ADDENDUM NO. 1

Project: 2019 South Side Wastewater Treatment Plant Primary Clarifier Equipment Placement

Owner: City of Kingsville

Addendum No. 1 Specifications Section: N/A Issue Date: 05/01/19

2 DRIVE ASSEMBLY
C5 SCALE: 1'-1/2" = 1'-0"

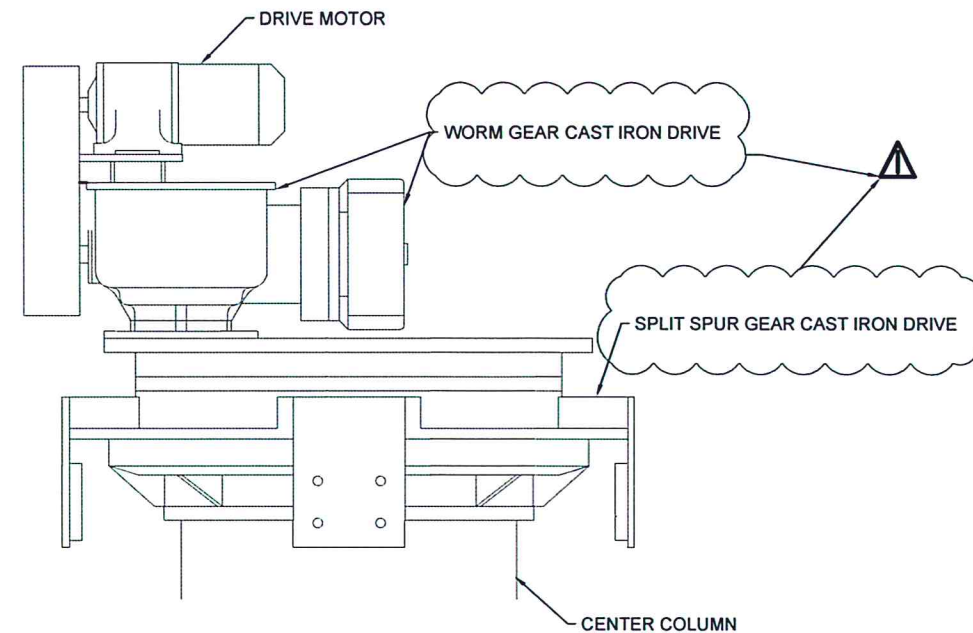
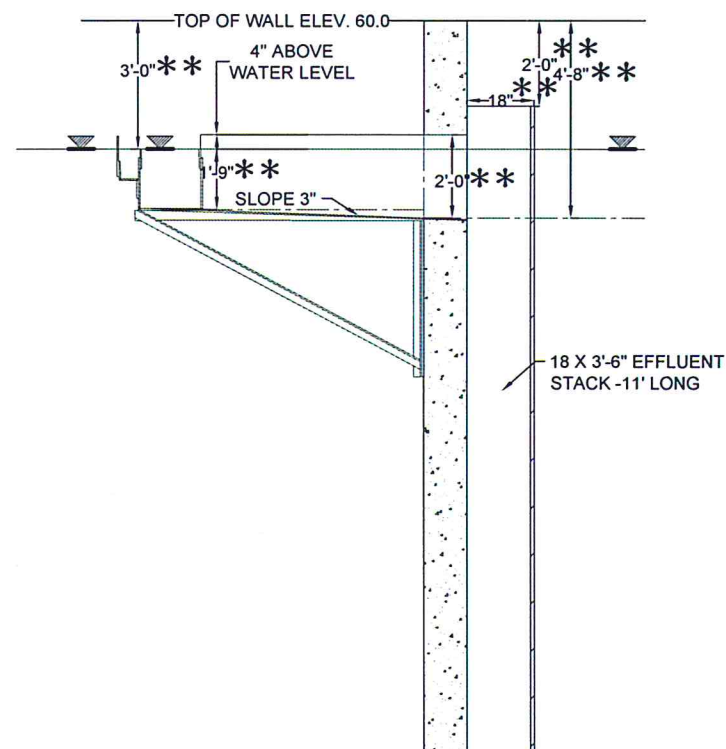
1. Project Completion Date revised from 180 to 270 consecutive calendar days. Revised documents include: Bid Proposal, Standard form of Agreement between City and Contractor, and General Conditions (Item 39)-Contract Period.
2. Revised Technical Specifications on section 464321 – Circular secondary Clarifier Equipment Pier Supported – Center Feed
3. Revised Bid Proposal posted on May 1,2019.
4. Addition of geotechnical report dated September 13, 2011.
5. Revised Clarifier Detail No. 2 on Sheet C5.

▲ REVISED AS PER ADDENDUM No. 1
